SERVICE BULLETIN

Subject: NON-REFLECTIVE TAPE FOR SENSOR COVERS
Applicable Products: S AND K SERIES LIFTS
Effective Date: 03-10-06

Figure [1] NON-REFLECTIVE TAPE PREP STAGE

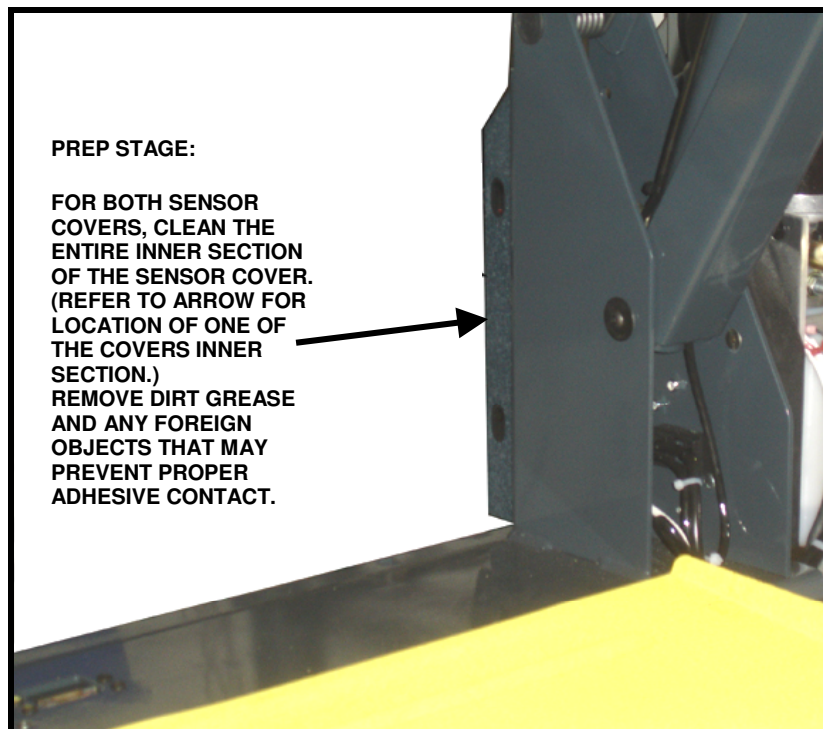
Ricon recommends the incorporation of this service bulletin when an object placed very close to an optical sensor does not activate the Threshold Warning System.

Corrective Action: Installation Non-reflective tape.

Parts Involved: Kit # 35707. The kit can be ordered by calling 1-800-322-2884, please have lift Serial number available.
